MILITARY SPECIFICATION SHEET

CIRCUIT BREAKERS, AIR, ELECTRIC,
INSULATED HOUSING (SHIPBOARD USE)
TYPE AQB - A50, A50D, A51, AND NQB - A50

FIGURE 1. Circuit breaker type AQB-A50, A50D, A51 and NQB-A50 outline and mounting dimensions.

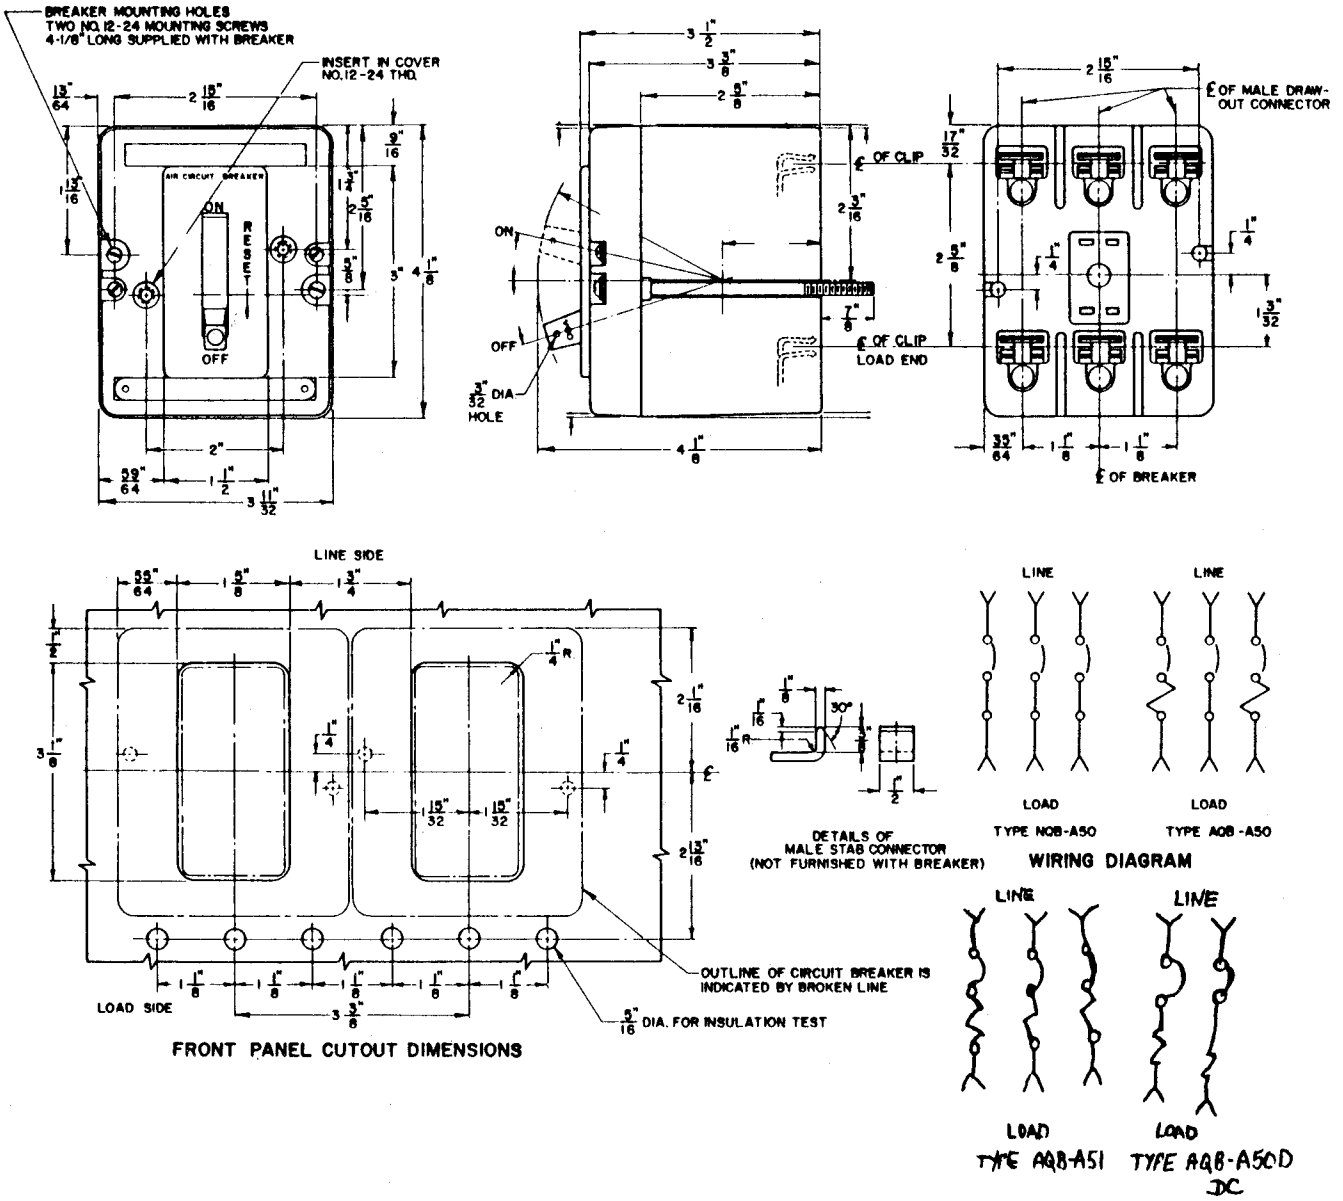
FIGURE 1: Delete and substitute new FIGURE 1:

New FIGURE 1.

FIGURE 2. Mounting bases for circuit breaker type AQB-A50, AQB-A50D, and AQB-A51outline and mounting dimensions.

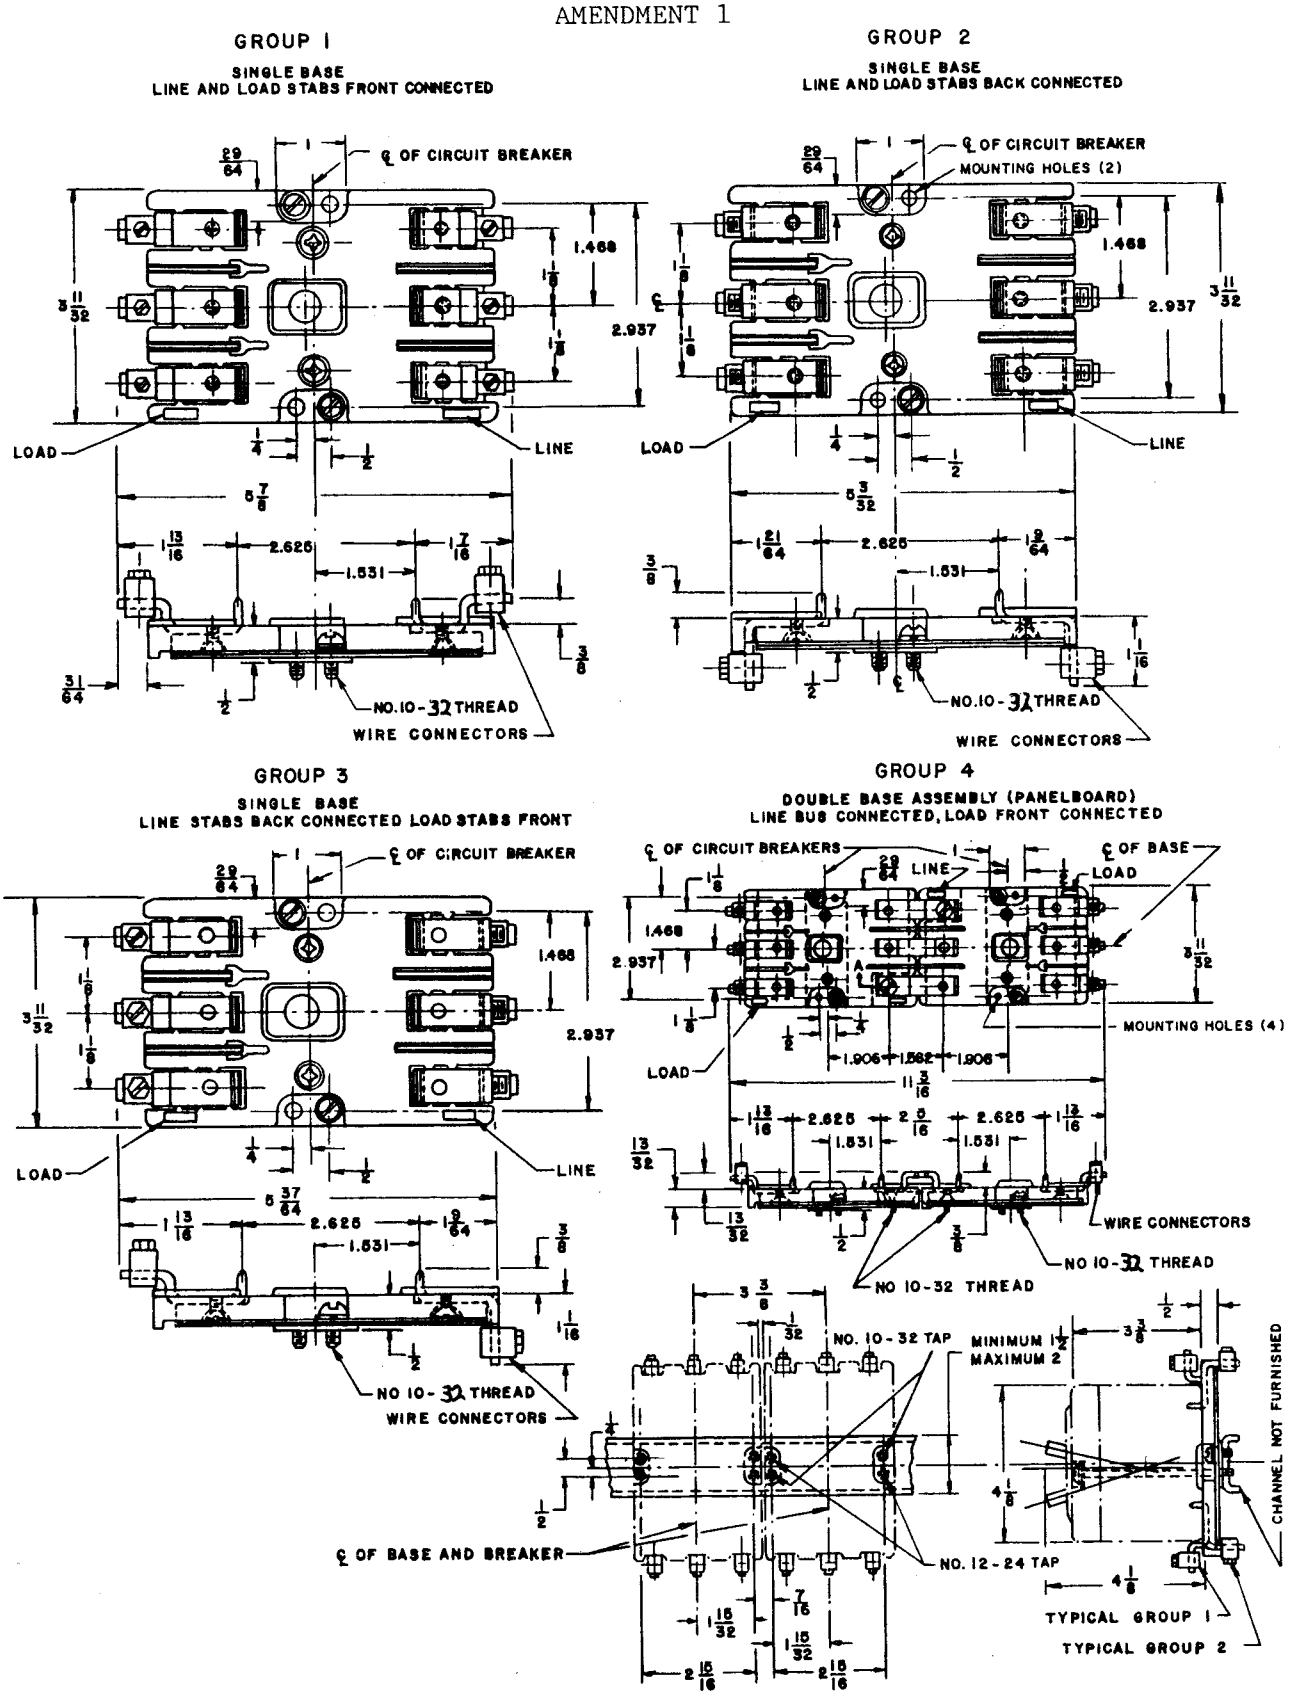
FIGURE 2: Delete and substitute new FIGURE 2:
